UNITED STATES
NUCLEAR REGULATORY COMMISSION
OFFICE OF INSPECTION AND ENFORCEMENT
WASHINGTON, D.C. 20555

April 14, 1981

IE Circular 81-06: POTENTIAL DEFICIENCY AFFECTING CERTAIN FOXBORO 10 to 50
MILLIAMPERE TRANSMITTERS

Subject: Potential Deficiency Affecting Foxboro Transmitters,
Model Numbers N-E11, N-E13 or E11, E13 with suffix
Codes /MCA, /MCA/RRW, or /MCA/RR

Amplifier Assembly

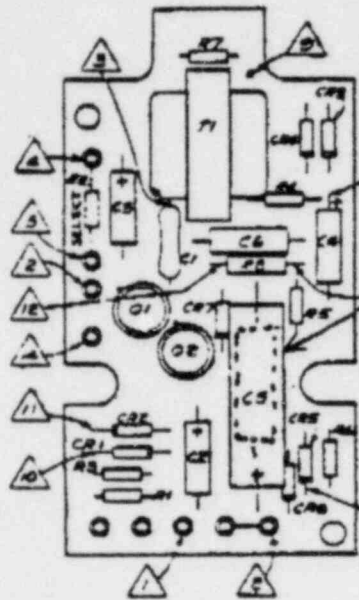
Capacitor
Look for Cornell-Dubilier;
smaller than component
shown. Identified by
code in form TX-65-XXXX,
07.

To determine if this capacitor is present requires a visual inspection of the amplifier which can be accomplished as described above for the insulating sleeving inspection. The recommended corrective action should the above described capacitor be present is to replace the amplifier (Foxboro P/N N0148PW) although it is possible to replace the capacitor with a Foxboro provided substitute. Use of Foxboro Service personnel to perform the inspection and replacement, if necessary, can be arranged at standard service rates as described above.

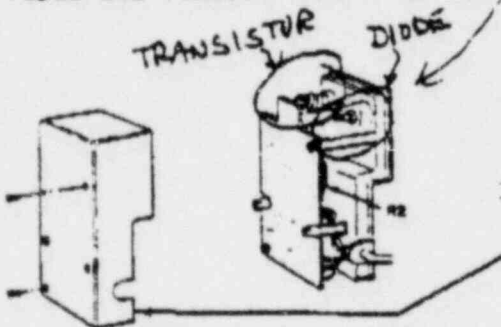
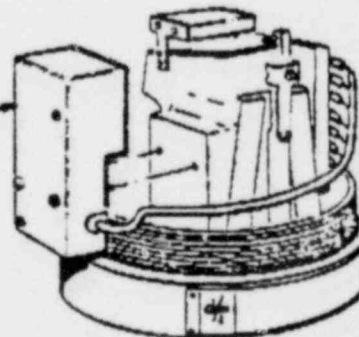
Transistor and diode check leads for insulation. If color is clear or single layer white, it is teflon and should be replaced.

If white cover over a braid, if it is polysulfone, the correct material.

If improper insulation is present, then the corrective action is to replace the amplifier (Foxboro P/N N0148PW). Replacement amplifiers can be purchased from your local Foxboro Sales or Service Representatives. If you prefer to have Foxboro Service Personnel inspect the equipment and, if necessary, replace the amplifier, this can be arranged at standard service rates.
